## 3 Responses to Comments

### 3.1 Introduction

### 3.2 Master Responses

**3.4 Project Sites**

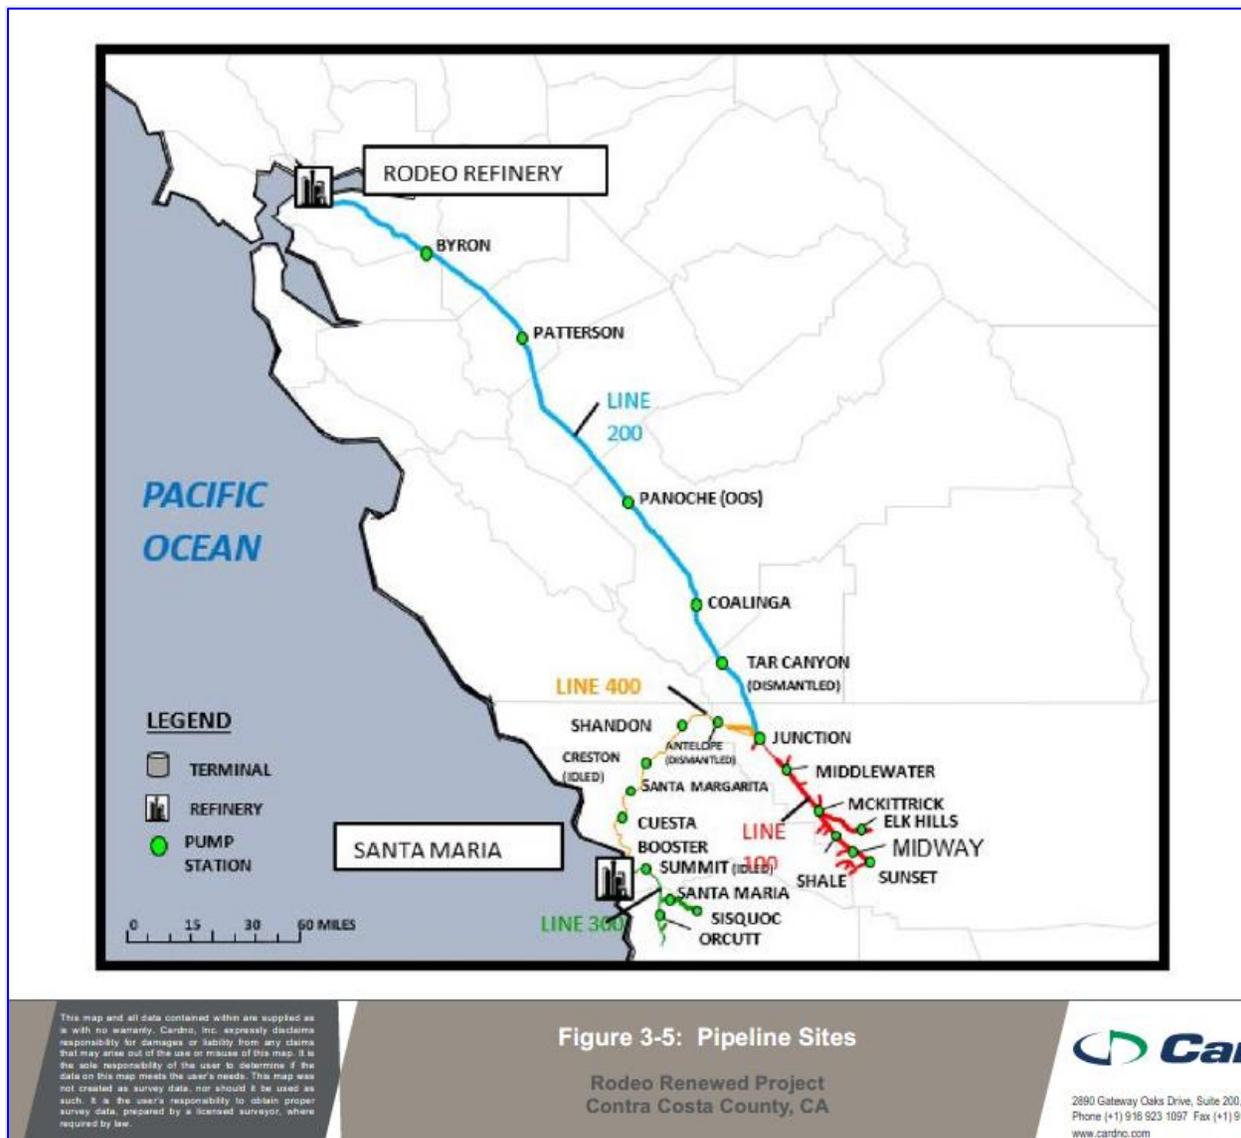
**Comment: The Draft EIR does not disclose the relationship between existing facilities and the Rodeo Renewed Project.**

Comments state that the Draft EIR fails to disclose the various components of the existing facilities and how they are related. The Draft EIR Chapter 3, Section 3.4, Project Sites is presented in part below. This section describes the existing facilities that would be affected by the Rodeo Renewed Project, including the Rodeo Site, the Carbon Plant, the Santa Maria Refinery and the Pipeline Sites.

As noted in the excerpt provided above, these are depicted in four figures, including Draft EIR Figure 3-5, Pipeline Sites, which depicts the locations of Lines 100, 200, 300 and 400.

Section 3.4.4 of the Draft EIR is revised as follows:

The Project includes the Pipeline Sites—four regional pipelines serving the Santa Maria Site and the Rodeo Refinery. The Santa Maria Site is connected to the Rodeo Refinery by approximately 200 miles of subterranean pipeline (Figure 3-5), designated Line 400 and Line 200. Line 400 runs north and east from the Santa Maria Site through the Coastal Range of central California in San Luis Obispo and Kern Counties, a region of dry grassland, pasture, and open live oak woodland, to connect with Line 200 north of McKittrick. Line 200 runs northwest up the west side of the San Joaquin Valley, through a mixture of Coastal Range grasslands and pasture and San Joaquin Valley agricultural land, and then west to the Rodeo Refinery. Line 200 runs through Kern, Kings, Fresno, Merced, Stanislaus, San Joaquin, Alameda, and Contra Costa Counties. ~~Two other pipelines—Line 100 and Line 300—connect the Santa Maria Site to crude oil collection facilities elsewhere in California (Figure 3-5). Line 100 runs underneath San Joaquin Valley agricultural land and Coastal Range grasslands and pasture lands in Kern County, and Line 300 runs beneath agricultural land and grasslands in the Santa Maria Valley area in San Luis Obispo and Santa Barbara Counties.~~ Line 100 is used to transport crude oil from several collection facilities in Central California to Line 200 at the Junction Pump Station. Line 100 runs underneath San Joaquin Valley agricultural land and Coastal Range grasslands and pasture lands in Kern County (Figure 3-5). Line 300 connects crude oil collection facilities elsewhere in California to the Santa Maria Site and runs beneath agricultural land and grasslands in the Santa Maria Valley area in San Luis Obispo and Santa Barbara counties (Figure 3-5).
